# Fosse Green Energy

EN010154

## 9.19 Applicant's Response to the Examining Authority's Second Written Questions

20 March 2026

Figure WQ2-1: Landscape and Visual Amenity Viewpoint Locations

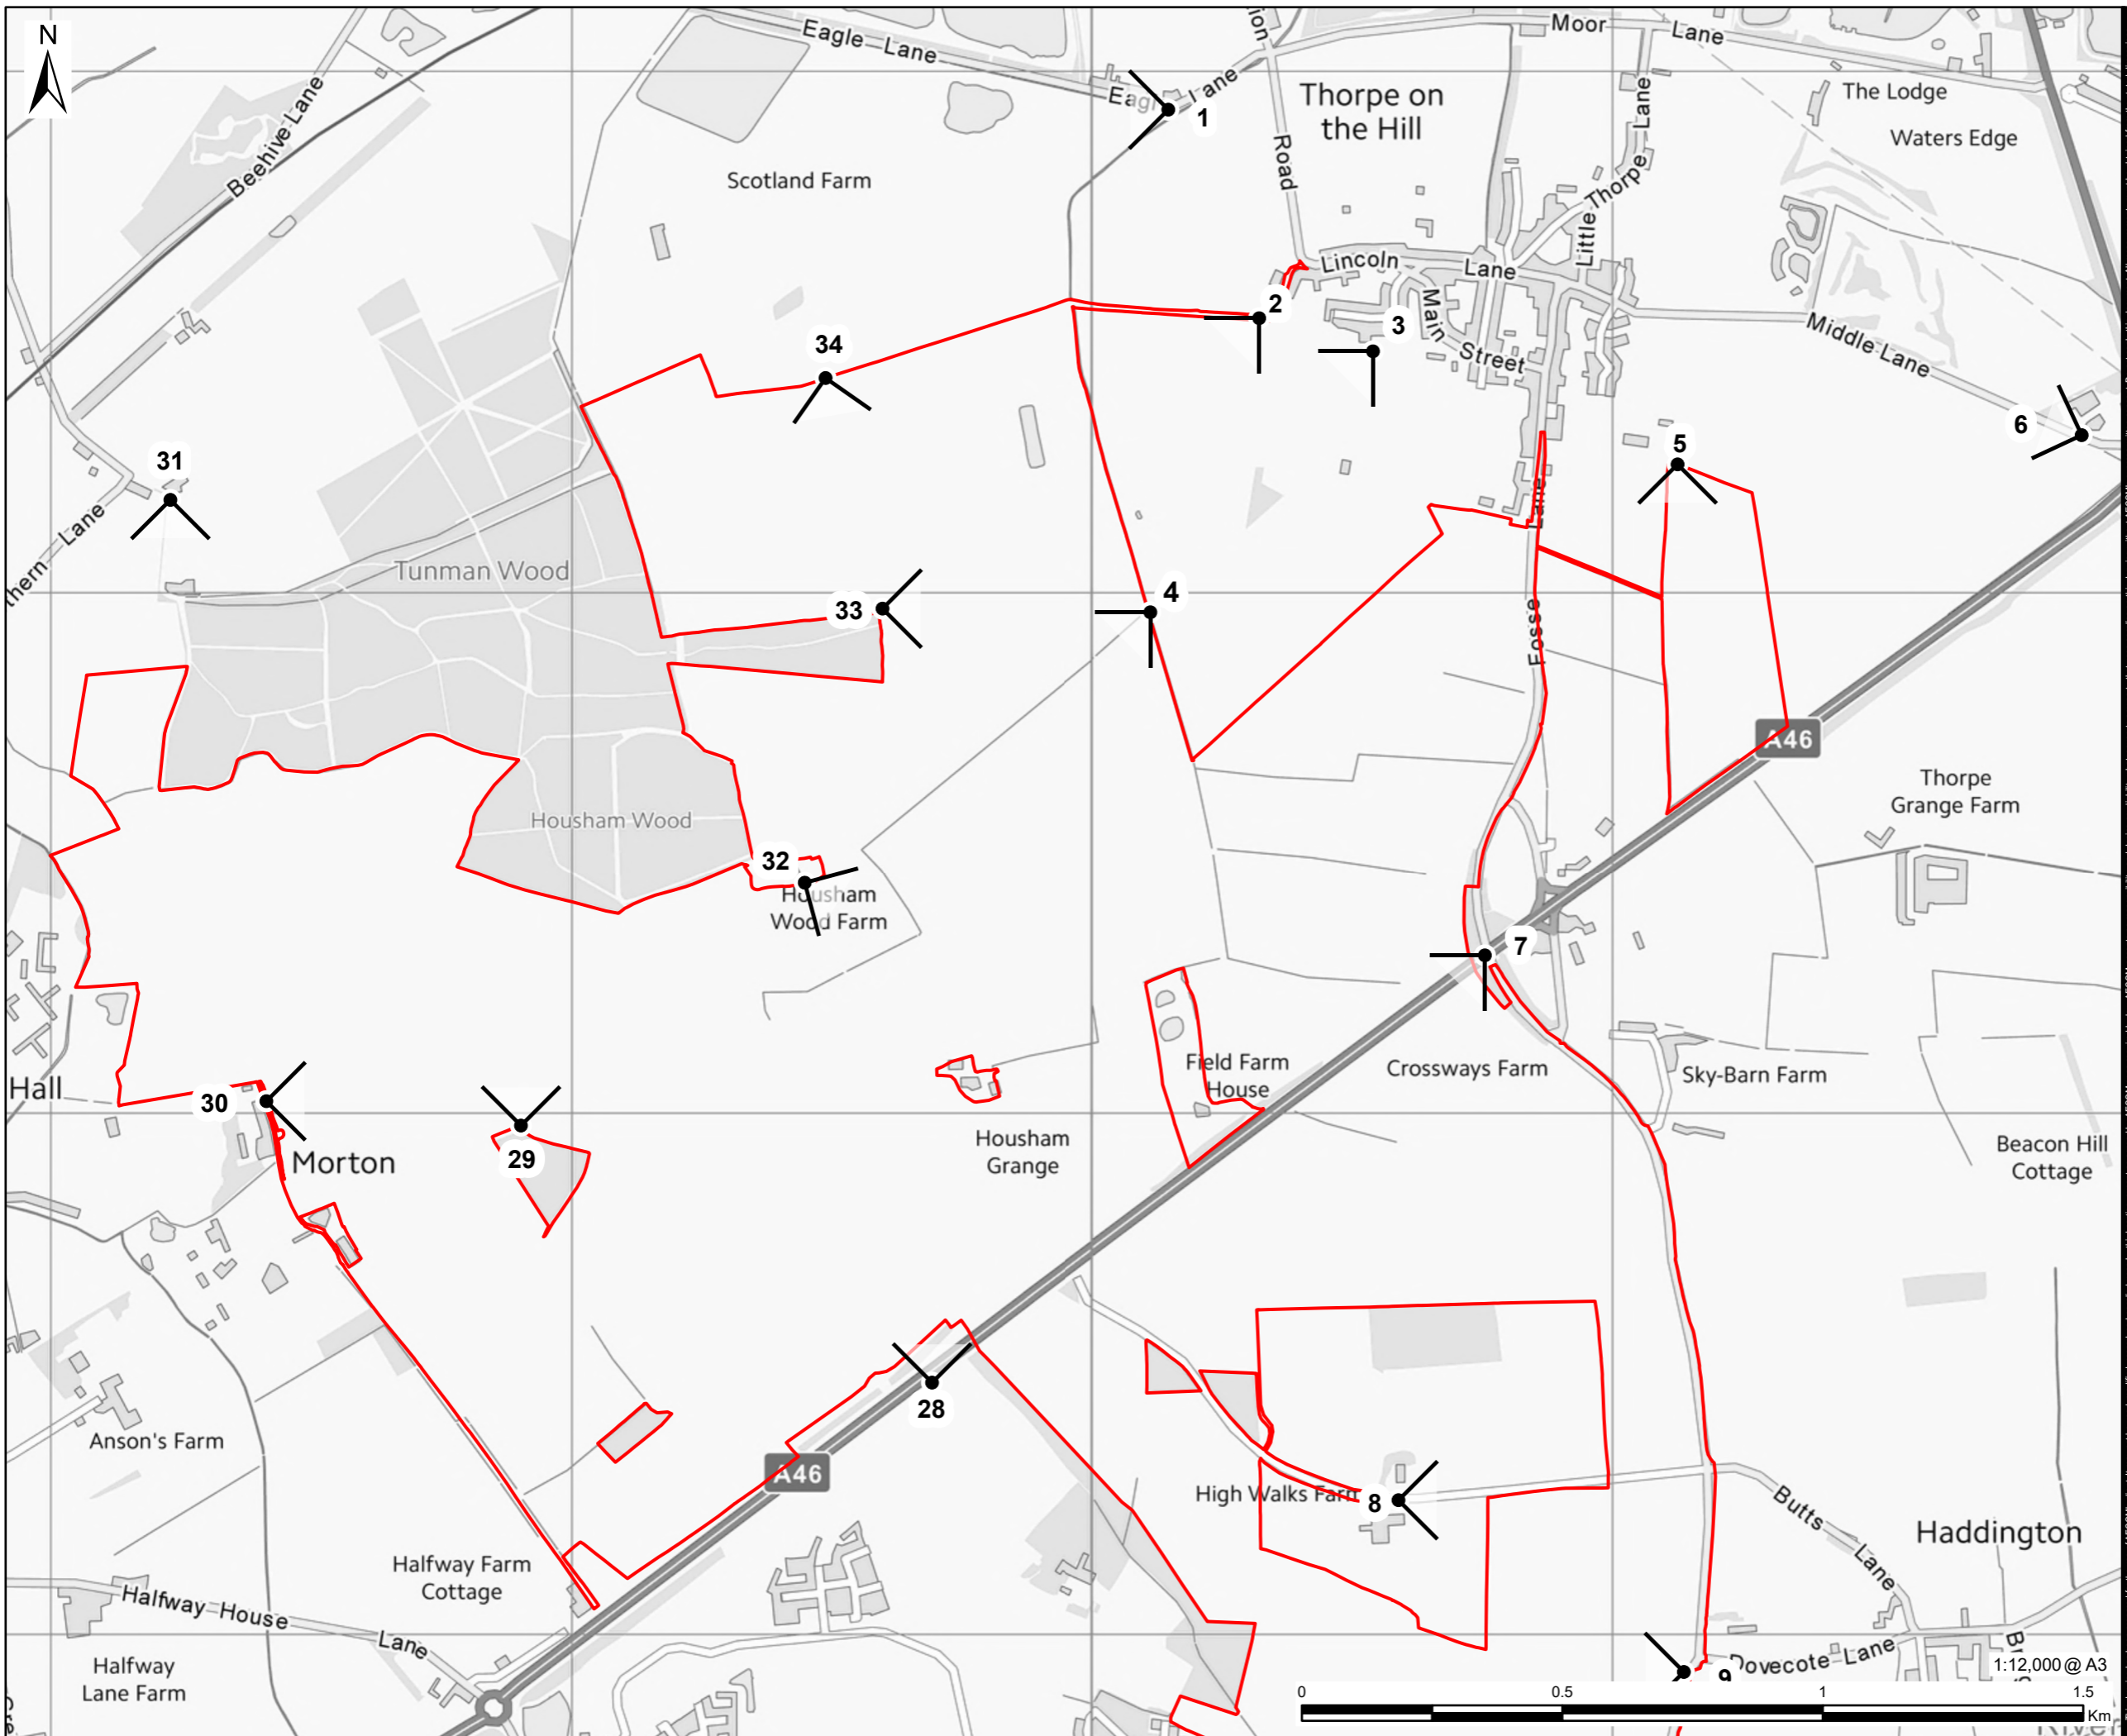
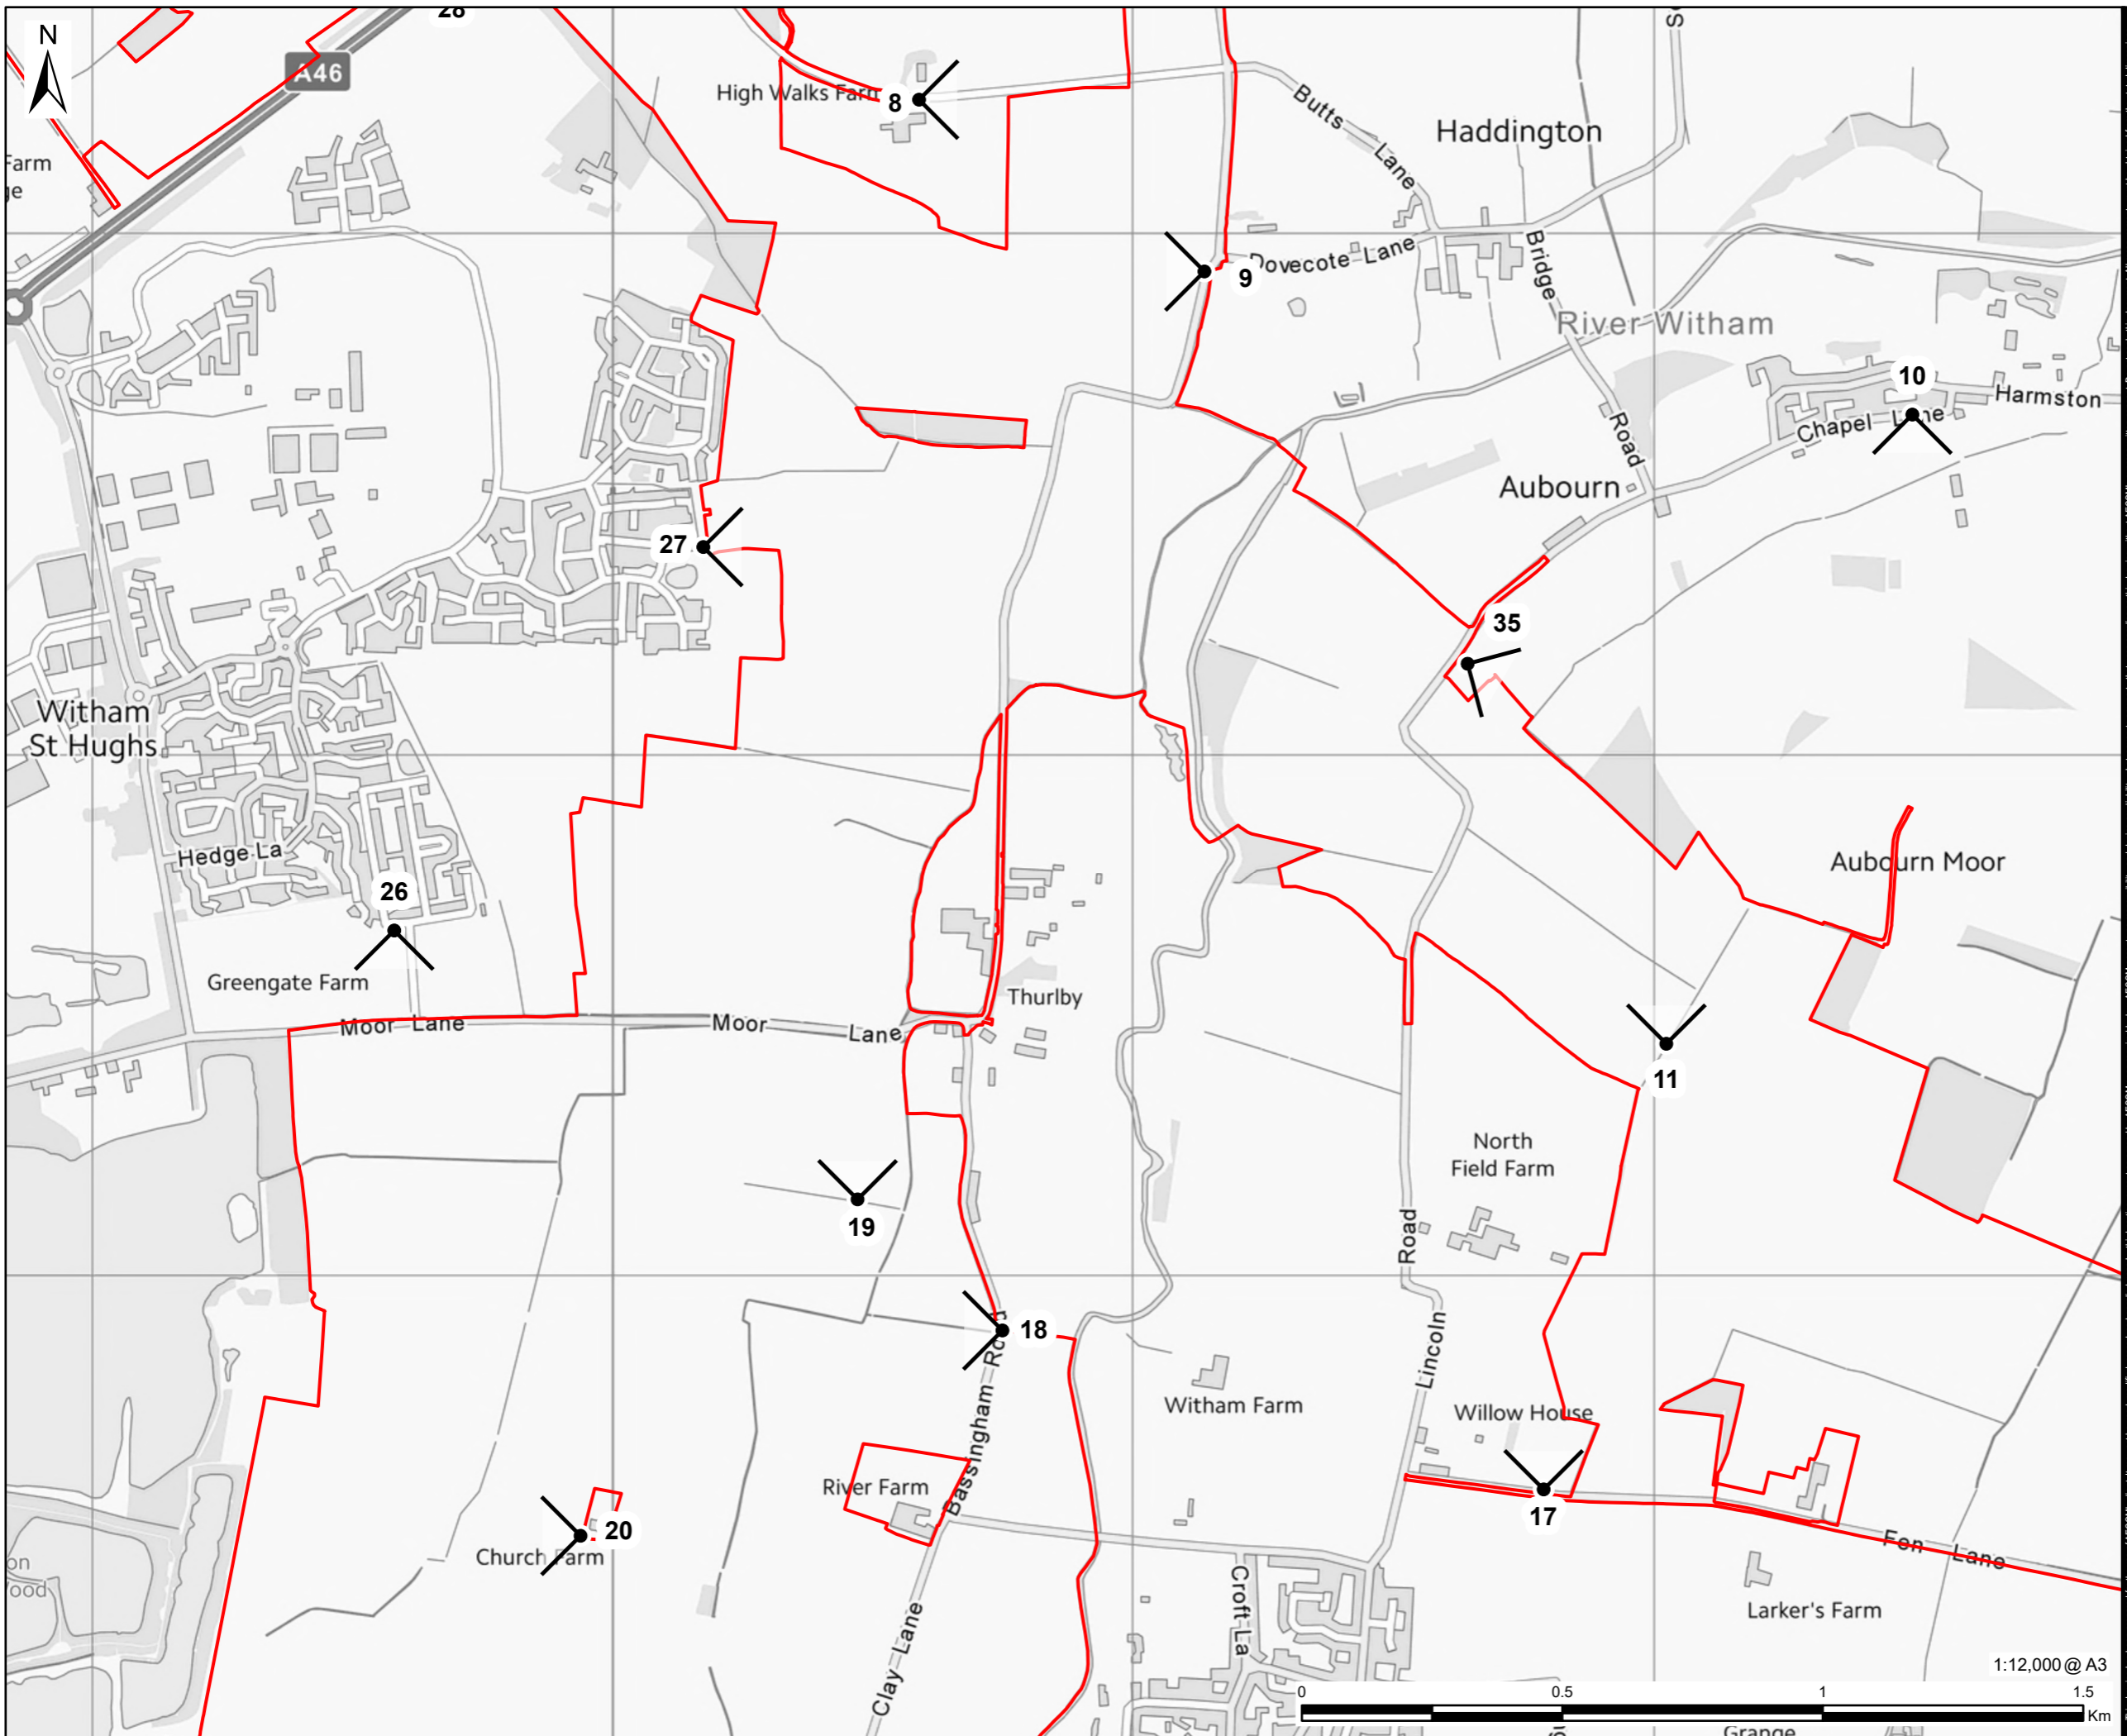
Question Number	Question to:	Question	Applicant Response
<b>Landscape and Visual (LV)</b>			
LV.2.01	Applicant	<p><b>Plans showing the locations for viewpoints and photomontages</b> The ExA notes the applicant's response to ExQ1 LV.1.01 (Plans showing the locations for viewpoints and photomontages), most particularly the reliance placed on ES Figure 10-7 Zone of Theoretical Visibility – Barrier Earth, with Viewpoint Locations (Rev B) [AS-059] as the means for identifying the locations for the viewpoints and photomontages used in the submitted assessment of the proposed development's landscape and visual amenity effects. However, ES Figure 10-7 [AS-059] is affected by limited contextual mapping information relating to road/street and property naming that the ExA referred to in item 1(a) in its procedural decision letter dated 22 August 2025 [PD-005]. That, taken together with the scale of ES Figure 10-7 (1:60,000), makes it difficult to identify the precise locations for some of the viewpoints and photomontages without recourse to other submitted figures.</p> <p>The ExA therefore considers the answer to ExQ1 LV.1.01 to be unsatisfactory. Accordingly, the applicant should submit a plan (or plans) appropriately scaled with adequate contextual information to enable the locations for the viewpoints and photomontage to be clearly identified.</p>	<p>Please see Figure WQ2-1 provided in Appendix A, which illustrates the location of the viewpoints at a 1:12,000 scale with additional contextual location information.</p> <p>Figure 10-8 Viewpoint Photography [APP-095] and Figure 10-10: Photomontages [APP-097] and [AS-119] of the ES also provide locational information (such as location coordinates) beneath each respective image.</p>
